Model: Model K-P1		Date: 18-Jan-01	No.: RG058001
Subject: Printer Controller Firmware History		Prepared by: K. Misugi	
From: Technical Services Dept., GTS Division			
Classification:	<input type="checkbox"/> Troubleshooting <input type="checkbox"/> Mechanical <input type="checkbox"/> Paper path <input type="checkbox"/> Other ()	<input type="checkbox"/> Part information <input type="checkbox"/> Electrical <input type="checkbox"/> Transmit/receive	<input checked="" type="checkbox"/> Action required <input type="checkbox"/> Service manual revision <input type="checkbox"/> Retrofit information

Printer controller firmware history for the Kir-P1 (G058/G056 model).

Model: Model K-P1		Date: 03-Apr-01	No.: RG058002
Subject: Printer Engine Firmware History		Prepared by: K. Misugi	
From: Technical Services Dept., GTS Division			
Classification:	<input type="checkbox"/> Troubleshooting <input type="checkbox"/> Part information <input type="checkbox"/> Action required <input type="checkbox"/> Mechanical <input type="checkbox"/> Electrical <input type="checkbox"/> Service manual revision <input type="checkbox"/> Paper path <input type="checkbox"/> Transmit/receive <input type="checkbox"/> Retr

CAUSE**Dirty background on the right side:**

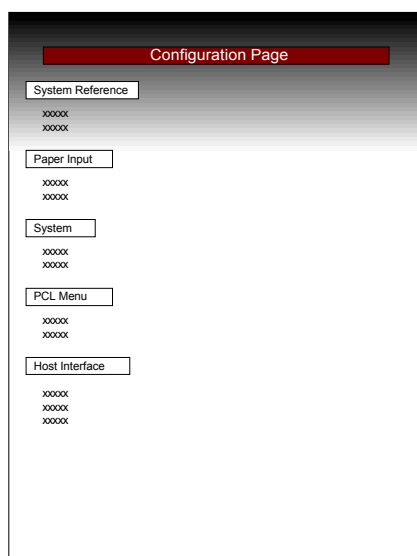
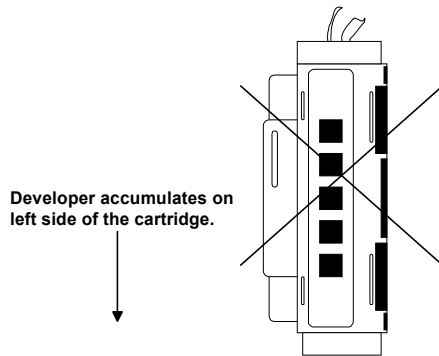
Dirty background may occur at installation, either on the right side or throughout the printout. The following is an example of dirty background on the right side with A4/LT LEF:

The developer will shift to the left side if the cartridge is tilted as shown below when the sealing tapes are being removed. This causes toner to be over-supplied on the right side of the cartridge, which in turn causes the dirty background on the right side of the printout.

This may occur when the user turns on the main switch without removing the tape seals or when the cartridge has been shaken after the seals are removed.

The position of the toner agitator is adjusted at the factory. When the main switch is turned on, the main motor turns the agitator. Then, when the user actually removes the seals and resets the cartridge in the machine, the agitator is no longer in the proper position, and this causes dirty background on the printouts.

If the cartridge is shaken after the tape seals are removed, dirty background may occur as the developer is not evenly distributed in the development unit.

This symptom may only occur at installation. If it should occur, please advise customers to print out 30 to 40 pages. In most cases, the symptom will gradually disappear.

- Remove the seals before turning on the main switch.
- Place the cartridge on a level surface when removing the seals.
- Once the seals have been removed, do not shake the cartridge.
Note: This only applies to cartridge installation and replacement.

- Strips of yellow tape have been added that will stick out of the machine, calling attention to the user to remove the tape seals inside before turning on the main switch.
- A label and caution sheet have been added cautioning the user not to tilt the cartridge when removing the seals.

3.3.5 Laser Diode Unit

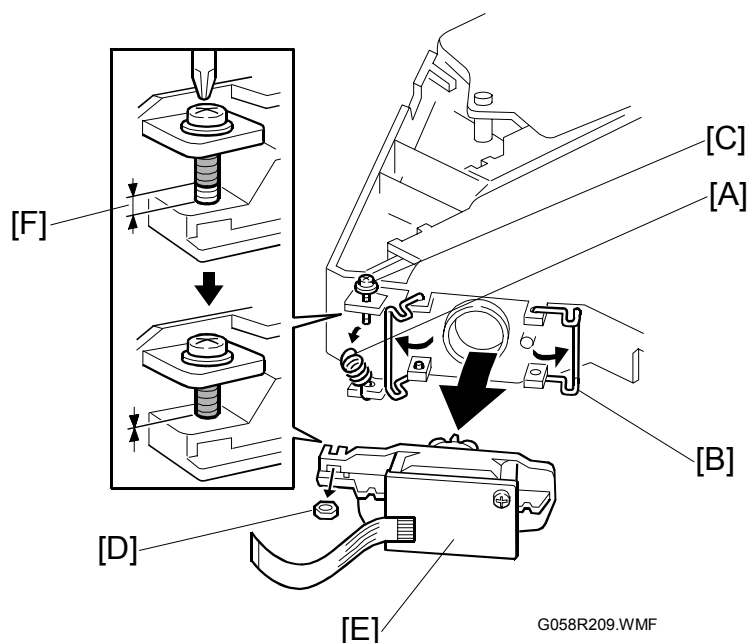
The Service Manual procedure for the LD unit position adjustment has been changed from the first machine of mass production. The new procedure is as follows:

Tighten the screw [C] until the unpainted portion of the screw [F] is not visible.

After installing the LD unit, check the test pattern for the final adjustment (see the following procedure).

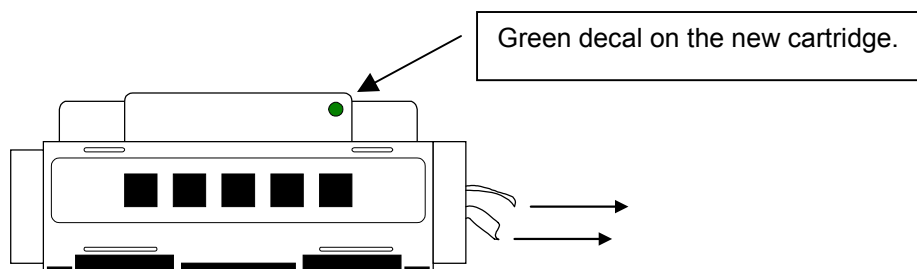
The cartridge has been modified from June production so that dirty background will not occur at installation even when the cartridge is tilted.

A green decal is added so the new cartridge can be distinguished from the old type. The same decal is also placed on the supply cartridge, next to the bar-code label on the box.

New service switch:

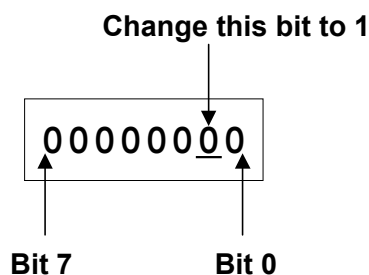
In response to complaints from customers that the intervals between jobs are too long when sent in series, a new service switch has been added to improve performance.

Controller SP mode bit switch 2, bit 1

Series print mode On/Off

Enter the printer controller service mode, access the bit switch settings display, then change bit 1 of bit switch 2 to "1."
